Product Change Notice (PCN)

Subject: Transfer of the wafer production site, and Transfer of the Final Test, Visual Inspection, and Packing site for the RZ/A1M, RZ/A1LU, and RZ/A1LC groups

Publication Date: 6/29/2026

Label Specification

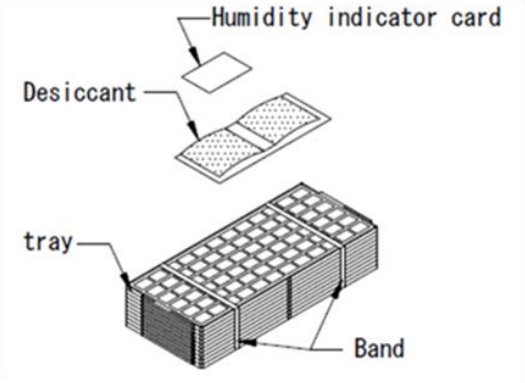
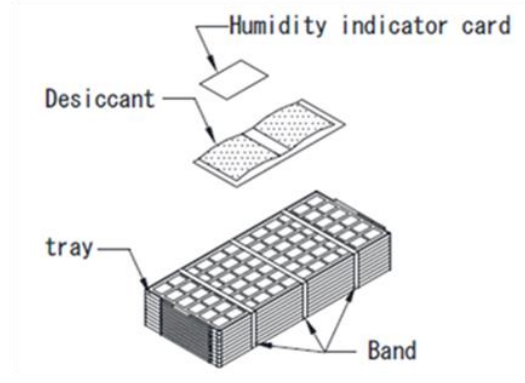
These are sample labels, and the areas highlighted in red indicate the changes.

【Current】	【After Change】
 Current label details: - D/N R7S721000VLFP - SPN R7S721000VLFP#AA0 AA0JG01000 - Pb-Free T. - AA0JG01000 - RENESAS - MSL:3 2017/10/30 - MC:JP:JP - MADE IN JAPAN - PID 17440Y200X-001 - QTY 100 (PARTIAL) - PCD P000000069 - T/C 1701 BA00003A S. LOT BA00003A	 After Change label details: - D/N R7S721000VLFP - SPN R7S721000VLFP#AA1 AA1WM01000 - Pb-Free T. - AA1WM01000 - RENESAS - MSL:3 2017/10/30 - MC:TW:JP - ASSEMBLED IN JAPAN - FROM WAREHOUSE OF TAIWAN - PID 17440Y200Y-001 - QTY 100 (PARTIAL) - PCD P000006373 - T/C 1701 BA00004A S. LOT BA00004A The internal code will change. The country of manufacture label will be changed.
